Metropolitan Development Commission Regional Center Hearing Examiner (July 23, 2026) Meeting Agenda

STAFF REPORT

Case Number	2026-REG-006
Address (approx.)	219 Koehne Street, 1437 – 1533 (odd) Saulcy Street, and 1422 – 1528 (even) Astor Street
Location	Center Township, Council District #18
Petitioner	Union Holdings III, LLC, by Misha Rabinowitch
Zoning	D-8 (RC)
Request	Regional Center Approval to provide for demolition of existing dwellings and accessory structures and for construction of a multi-family residential development, consisting of approximately 241 units, an integrated parking garage with 258 spaces, and resident amenities, including a community room, a playground, dog park, and grilling area.

Schematic
Elevations - 3d
Views

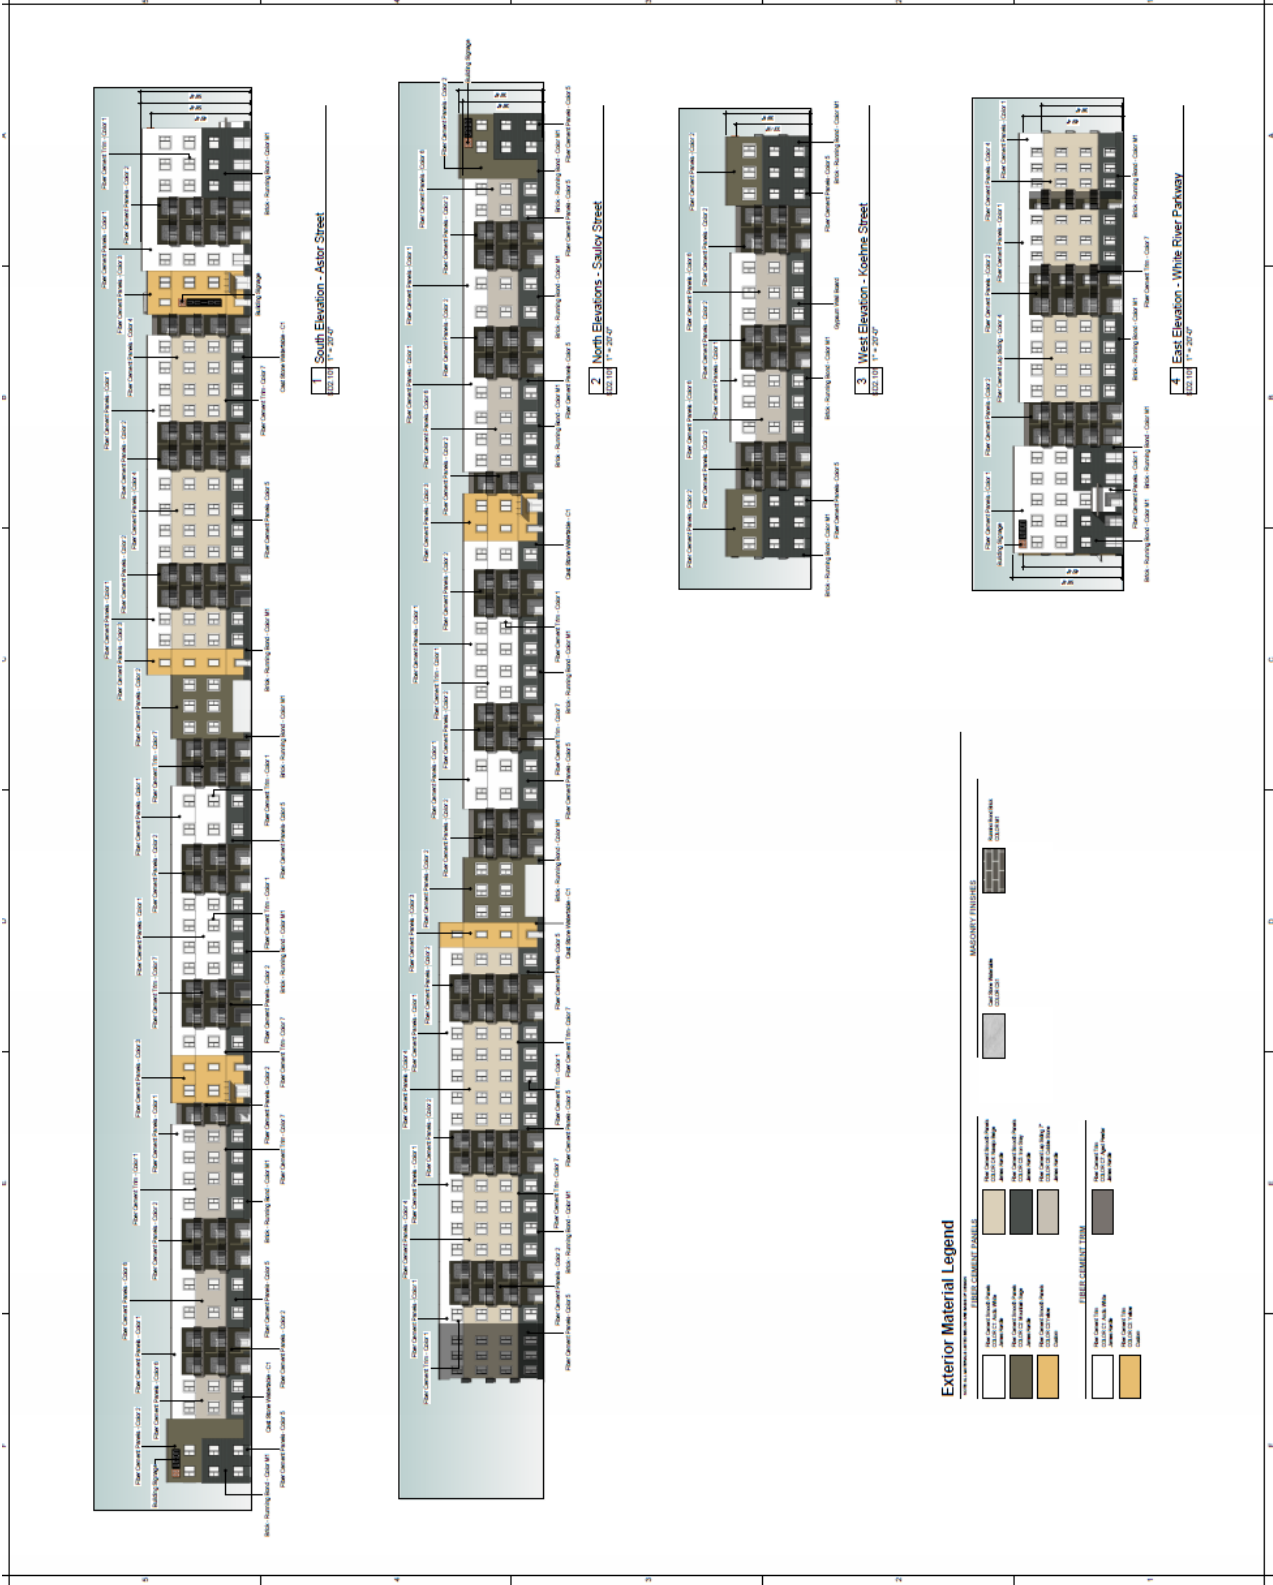
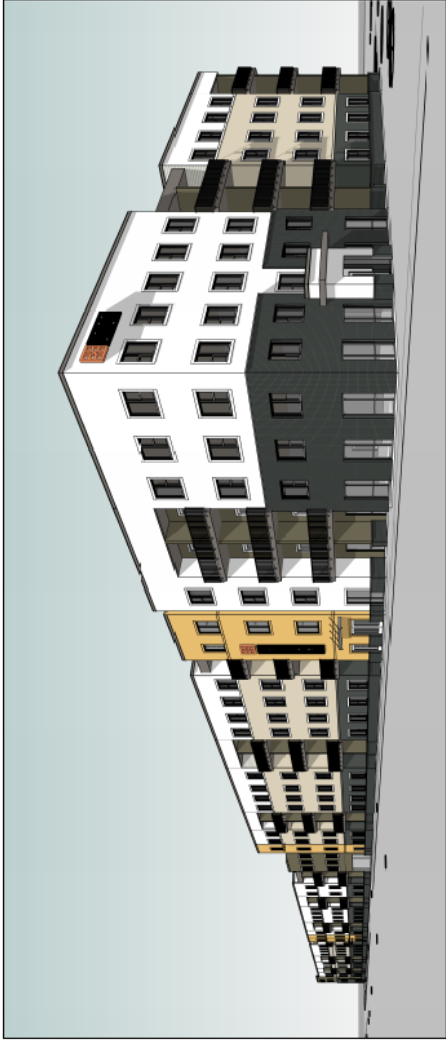
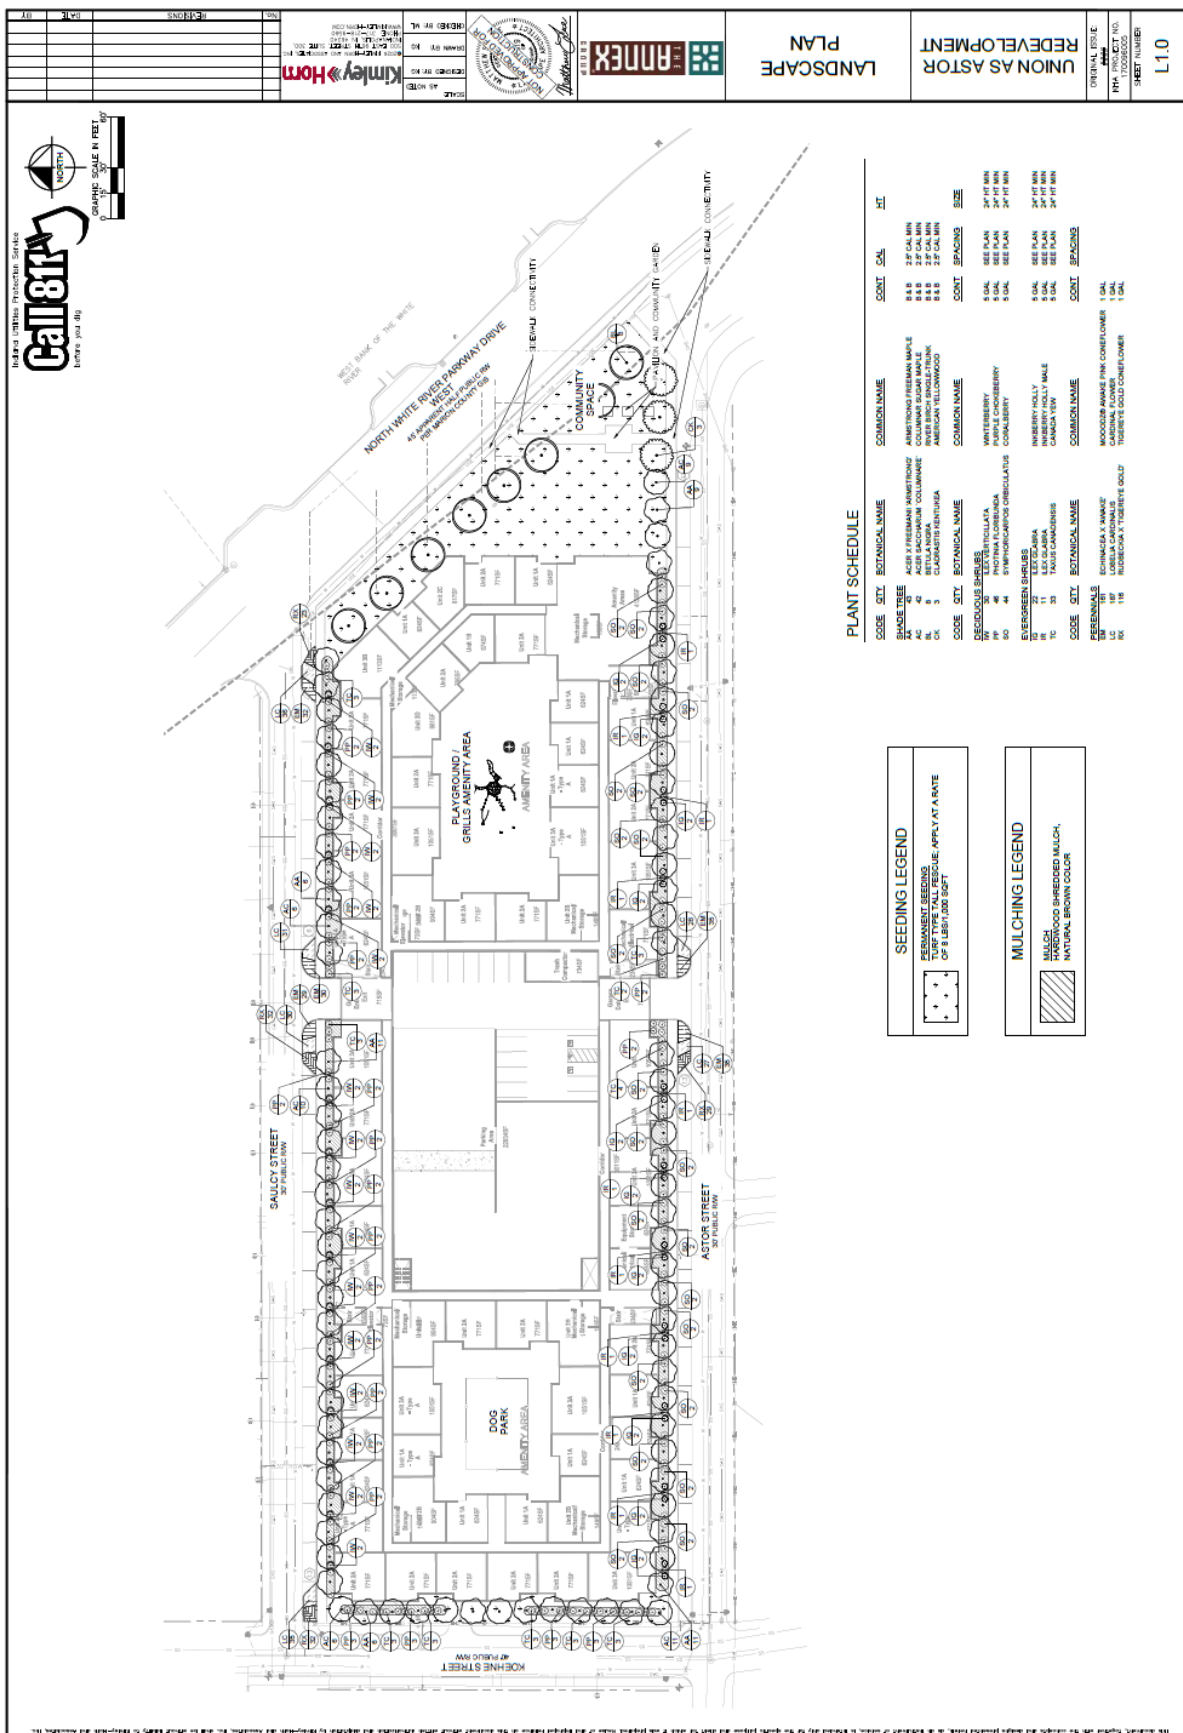
Building materials would be primarily fiber cement with a brick base, and larger sections of brick on the west façade that wraps around the building corners and at the first and second levels on south portion of the east façade and wraps around the corner.

2. The building materials is primarily made of fiber cement, a man-made material. Staff requested additional natural building material. Subsequent revised elevations note added areas of brick on the façade. Guideline CA 2.2.1 applies.
